CIVIL AVIATION AUTHORITY OF NEW ZEALAND

AIRWORTHINESS DIRECTIVES

Amendment Nr 26-07

Effective date 23 July 2026

Figure: Airbus Helicopters recommended CG position of forward two-place seat

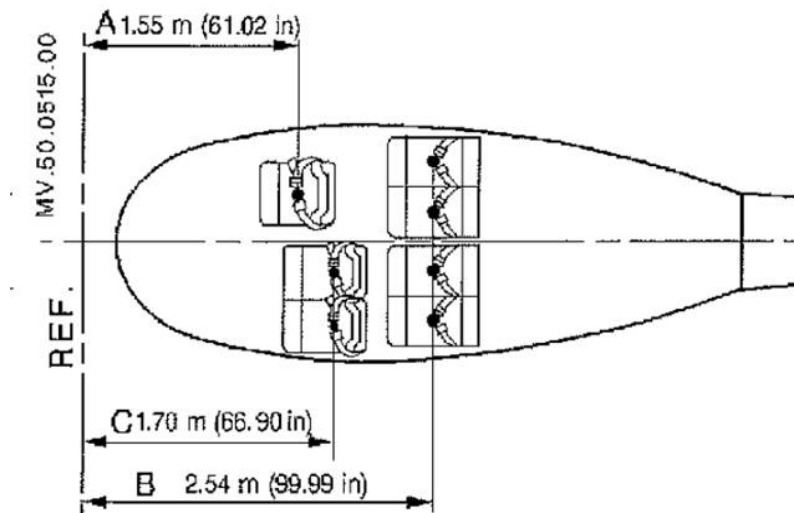
2. Remove CAA Limitations Section, (1 page), dated 14 December 2015 and insert 1 page dated 30 June 2016.

Figure: Airbus Helicopters recommended CG position of forward two-place seat.

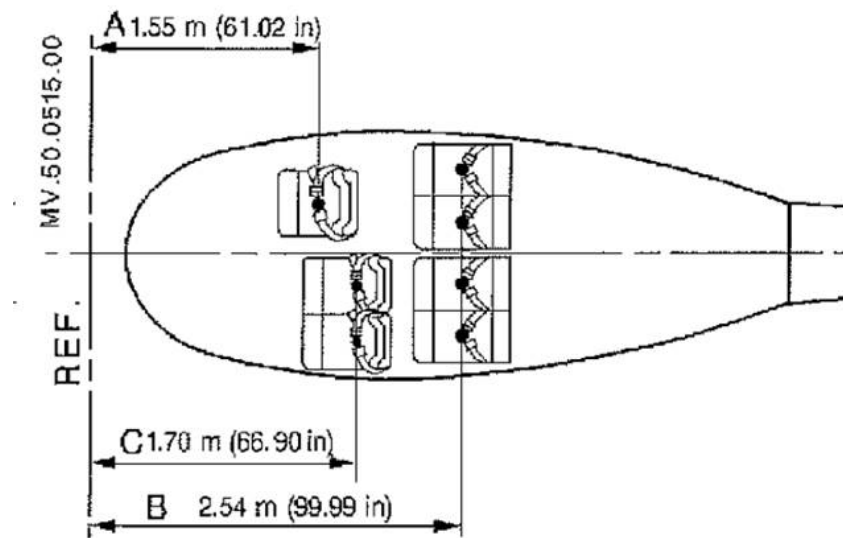
Annotate the CAA2173 to include the value of the longitudinal moment arm of the forward two-place seat used.

2. Remove CAA Limitations Section, (1 page), dated 14 December 2015 and insert 1 page dated 30 June 2016.
